CITY OF CALISTOGA

STAFF REPORT

SUBJECT: CONCEPTUAL DESIGN REVIEW (CDR 2012-01) – BERRY
STREET COTTAGES

FIGURE 1 - CONCEPTUAL DEVELOPMENT PLAN

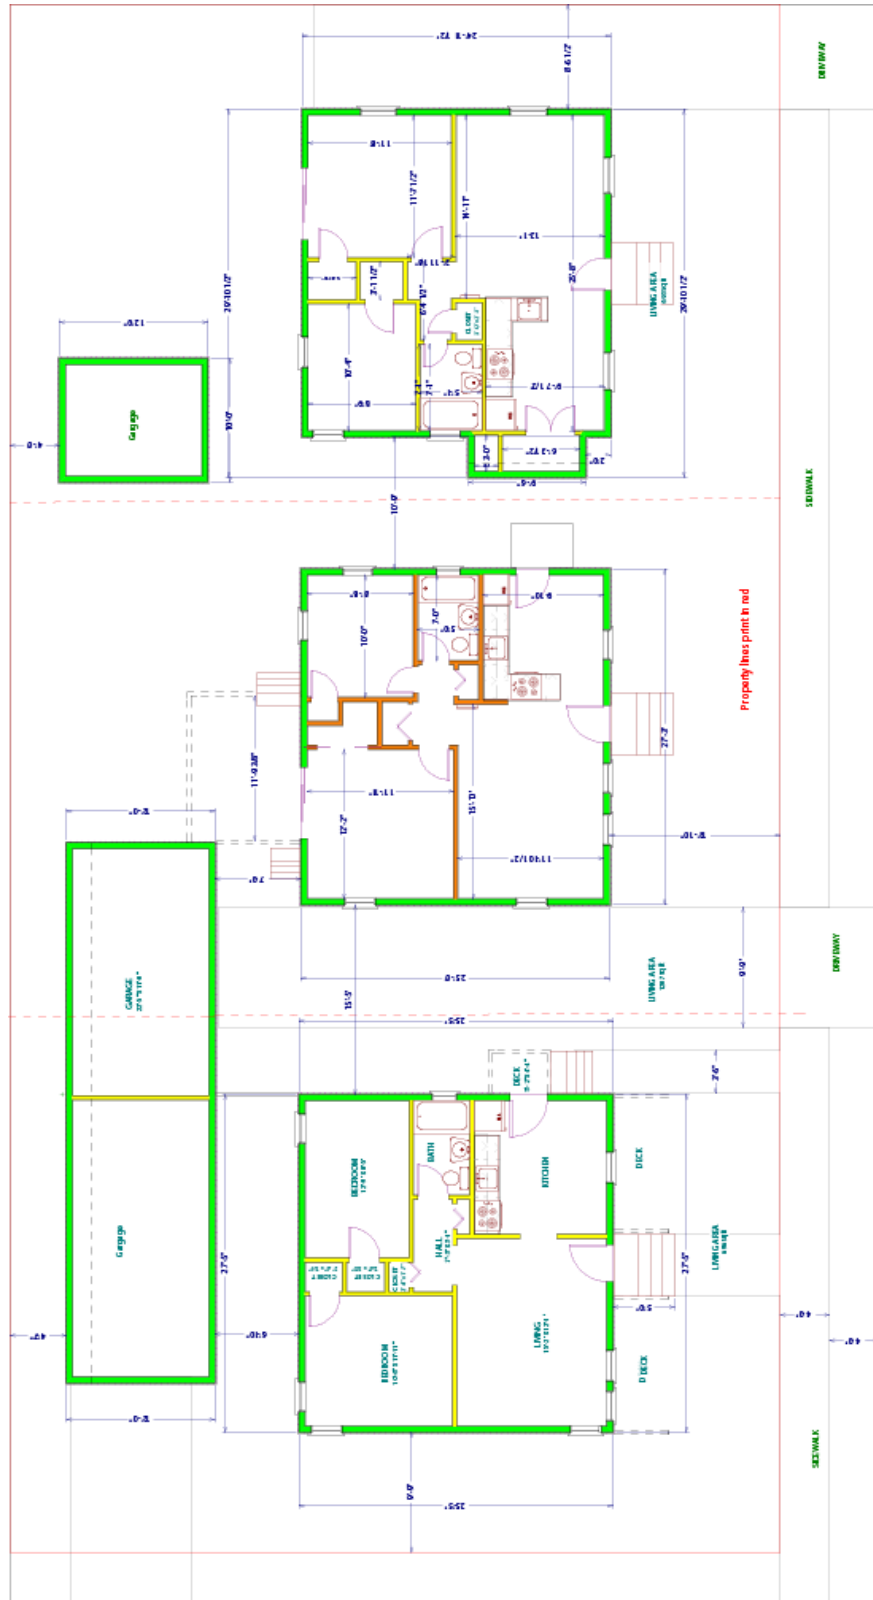
131 Table 1 shows that the development concept would deviate from current
132 development standards in the following six areas: (1) Myrtle Street exterior side
133 yard setback; (2) interior side yard setback for existing structures; (3) garage
134 setback; (4) accessory structure setback for existing structures; (5) minimum lot
135 width and depth; and (6) on-site parking outside of required yard setback areas.
136

- 137 1. Myrtle Street Exterior Side Yard Setback: The base zone standard for an
138 exterior side (corner) yard setback is 15 feet. The existing structure located
139 on the proposed lot at the corner of Myrtle and Berry Streets currently does
140 not meet this setback requirement nor would it meet the required setback if
141 the property were to be subdivided as contemplated. Based on the current
142 location of the existing structure on this lot, the exterior side yard setback
143 requirement would have to be reduced from 15 feet to 9 feet.
144

- 145 2. Interior Side Yard Setback: The base zone standard for an interior side
146 yard setback from the property line is 5 feet. On the proposed lot closest to
147 Foothill Boulevard, a portion of the existing structure appears to be
148 approximately 2 feet from the proposed interior property line. Based on this
149 condition, the interior side yard setback requirement would have to be
150 reduced from 5 feet to 2 feet. Staff would recommend that a separate
151 standard of 5 feet be established for new buildings as part of the Planned
152 Development Zoning District standards.
153

- 154 3. Garage Setback: The base zone setback standard for a garage facing a
155 public street is 20 feet. The owner has indicated that a new garage will be
156 constructed on the proposed lot at the corner of Myrtle and Berry Streets in
157 generally the same location as the existing garage (which as been
158 demolished). Based on this location, staff believes that the setback
159 distance will need to be reduced from 20 feet to 13 feet.
160

- 161 4. Accessory Structure Setback: The base zone standard for side and rear
162 yard setbacks for an accessory structure is 5 feet. On the proposed center
163 lot and on the lot closest to Foothill Boulevard the existing garage structures
164 appear to be closer than five feet from the proposed interior and rear
165 property lines. Based on the location of these structures, the side yard and
166 rear yard setback requirements would have to be reduced from 5 feet to
167 approximately 2 feet. Staff would recommend that a separate standard of 5
168 feet be established for new buildings as part of the Planned Development
169 Zoning District standards.
170

- 171 5. Minimum Lot Width and Depth: The base zone setback standards for
172 minimum lot width and depth dimensions are 60 feet and 100 feet
173 respectively. The existing property is 60 feet wide and 120 feet deep.
174 Division of the property into three lots will require a reduction to the

175 minimum standards for lot width from 60 feet to 40 feet. For lot depth, the
176 minimum standard will need to be reduced from 100 feet to 60 feet.
177

178 6. On-Site Parking Requirements: In all zoning districts, required on-site
179 parking must be located outside of all required yard setbacks (17.36.050
180 Calistoga Municipal Code). With the exception of the garage on the
181 proposed corner lot at Myrtle and Berry Streets, it appears that the existing
182 garage structures will need to be expanded to be large enough to
183 accommodate parking for one vehicle. If a second vehicle is to be parked
184 on-site, it will inevitably have to be parked within a required setback area
185 given the small size of the proposed lots. This would require that an
186 exception to the requirements of 17.36.050 of the Municipal Code be
187 included in the proposed Planned Development district.
188

189 Staff is concerned about the potential for future owners to use the garage
190 structure for storage of personal belongings (given the small size of the
191 homes), which would then result in two cars potentially being parked in the
192 rear and side yard (driveway) areas. Given the close proximity of the
193 homes, staff believes that vehicle parking in the driveways could be
194 disruptive to adjoining property owners and diminish the quality of the living
195 environment.
196

197 Staff is seeking the Planning Commission's comment/guidance on
198 discussing the possibility of eliminating on-site parking requirements for the
199 two subject lots with the owner. In this scenario, future owners and their
200 guests would be required to park on the street.
201
